**SUBJECT: JWBWH LOBBY AUDIO VIDEO MODIFICATION – ADDENDUM #2**

#### **DRAWING CLARIFICATIONS**

1. Drawing clarification No. 1

**1** ENLARGED LOBBY PLAN  
A-403 SCALE: 1/4" = 1' - 0"

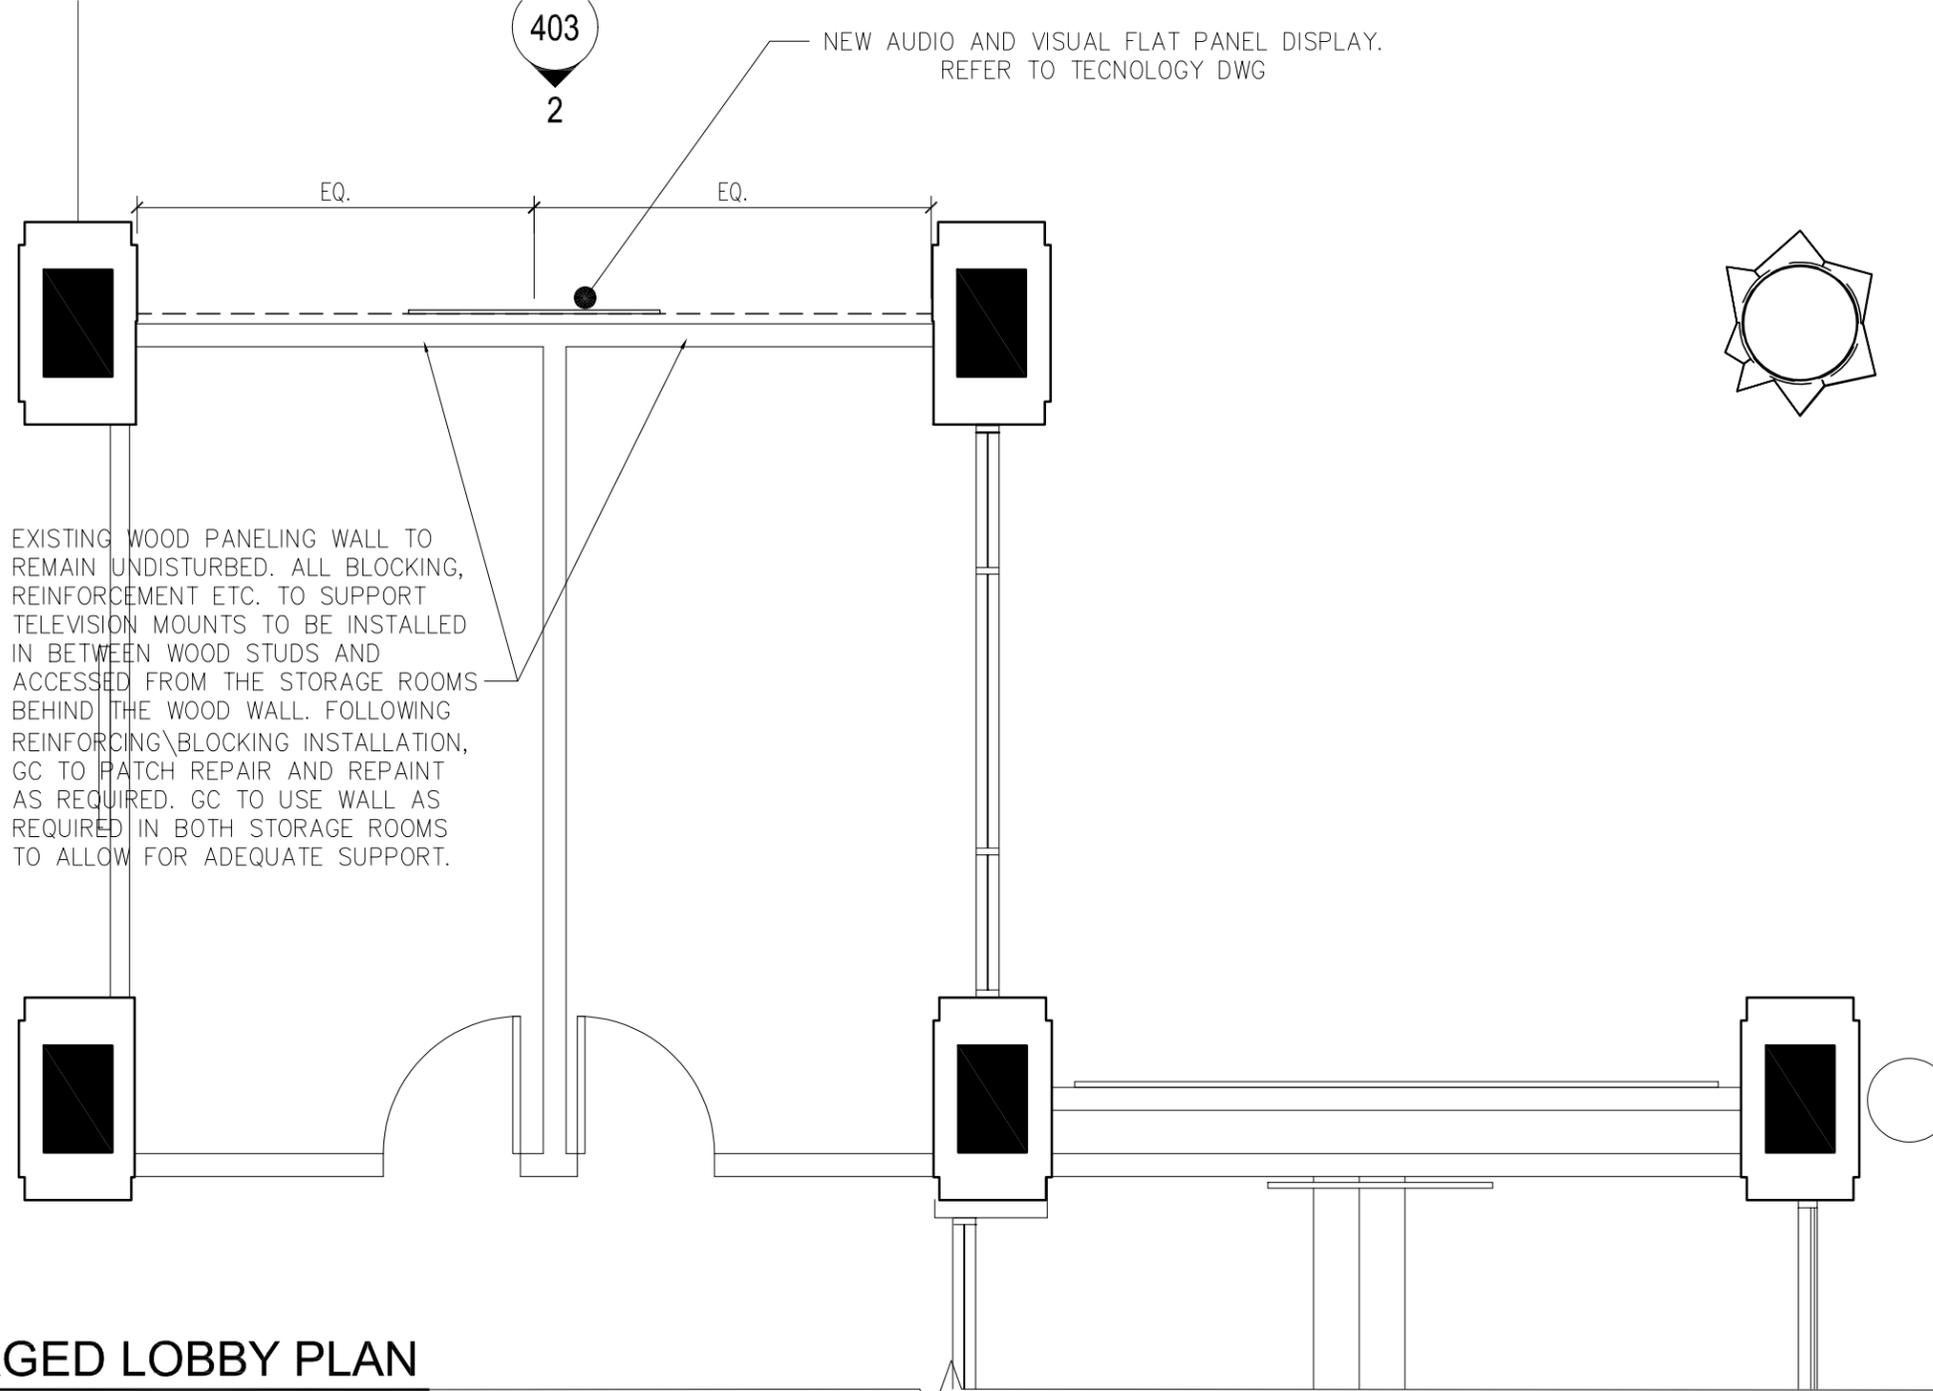
See the attached which is made part of the plans and specification via Addendum 2

**ELEVATION VIDEO WALL AT MUSEUM DISPLAY**

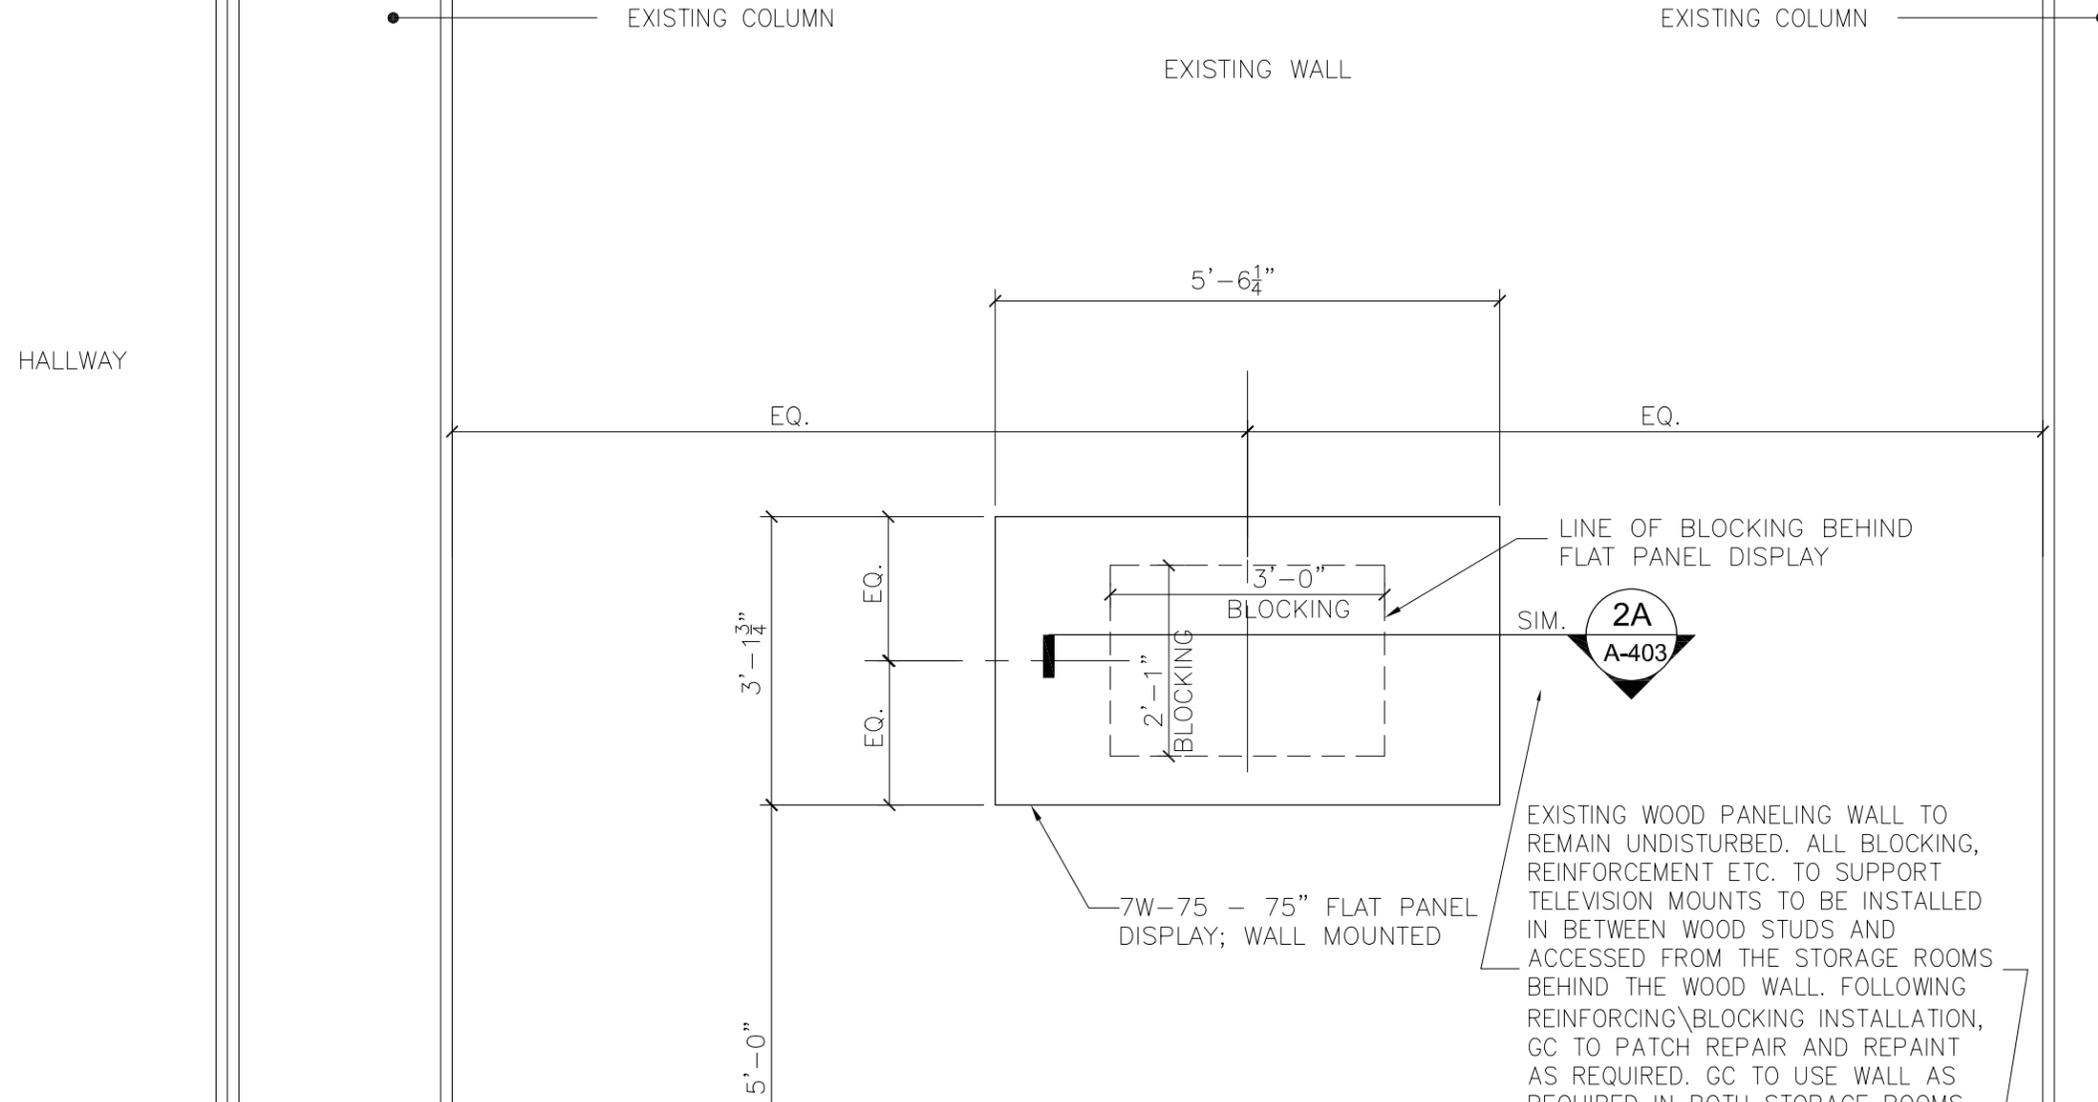
EXISTING WOOD PANELING WALL TO  
REMAIN UNDISTURBED. ALL BLOCKING,  
REINFORCEMENT ETC. TO SUPPORT  
TELEVISION MOUNTS TO BE INSTALLED  
IN BETWEEN WOOD STUDS AND  
ACCESSED FROM THE STORAGE ROOMS  
BEHIND THE WOOD WALL. FOLLOWING  
REINFORCING\BLOCKING INSTALLATION,  
GC TO PATCH REPAIR AND REPAINT  
AS REQUIRED. GC TO USE WALL AS  
REQUIRED IN BOTH STORAGE ROOMS  
TO ALLOW FOR ADEQUATE SUPPORT.
